Access Compliance Report

Public Rights-of-Way

(Curb Ramps)

Intersection ID: N/A	Main Street: HICKORY GROVE RD	Cross Street: MARTHA'S RIDGE DR	Location: SE
ADA ID: 6B571B49D818	Ramp Type: Combination2Diag	Initial Pass/Fail: Fail	Overall Compliance: No
		Severity Score: 0

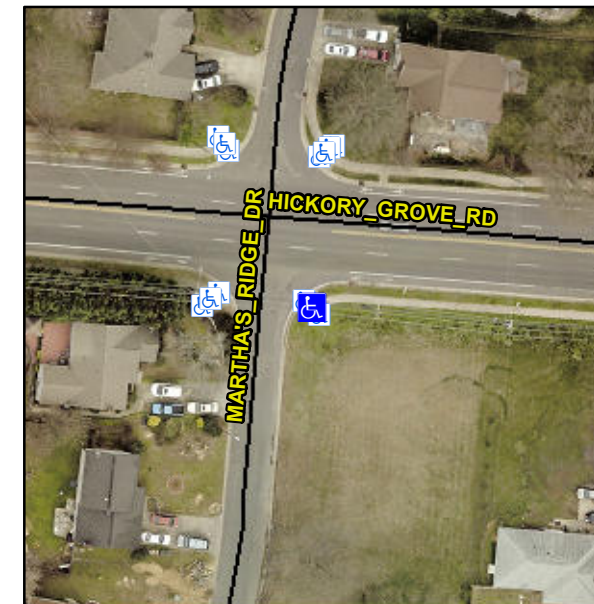
R304.5.1, R304.2.2, R304.5.3, R304.3.2

Compliance	Description	Data	Compliance	Description	Data
N/A	Ramp Length LT (in)	52.0	N/A	Ramp Length RT (in)	48.0
Yes	Ramp Width LT (in)	60.0	Yes	Ramp Width RT (in)	60.5
No	Ramp Slope LT (%)	9.9	Yes	Ramp Slope RT (%)	2.3
Yes	Ramp XSlope LT (%)	0.9	Yes	Ramp XSlope RT (%)	1.4
N/A	Ramp Length (in)	48.0	No	Ramp Slope (%)	9.1
No	Ramp Width (in)	40.0	No	Ramp XSlope (%)	3.5
N/A	Flare Type LT	N/A	N/A	Flare Type RT	N/A
N/A	Flare Slope LT (%)	N/A	N/A	Flare Slope RT (%)	N/A
N/A	Flare Traversable LT?	N/A	N/A	Flare Traversable RT?	N/A
N/A	Landing Length (in)	N/A	N/A	DWS Provided?	N/A
N/A	Landing Width (in)	N/A	N/A	DWS Contrast?	N/A
N/A	Landing Slope (%)	N/A	N/A	DWS Length (in)	N/A
N/A	Landing X Slope (%)	N/A	N/A	DWS Full Width?	N/A
N/A	Landing Curb? (Y/N)	N/A	N/A	DWS Offset (in)	N/A
N/A	Shared Landing?	N/A			
N/A	Gutter Ponding?	N/A	N/A	Gutter Slope (%)	N/A
N/A	Gutter Lip Ht (in)	N/A	N/A	Gutter X Slope (%)	N/A
N/A	Painted X Walk1?	No	N/A	Painted X Walk2?	No

Remove & Replace Curb Ramp With Two New Directional Ramps or Equivalent.
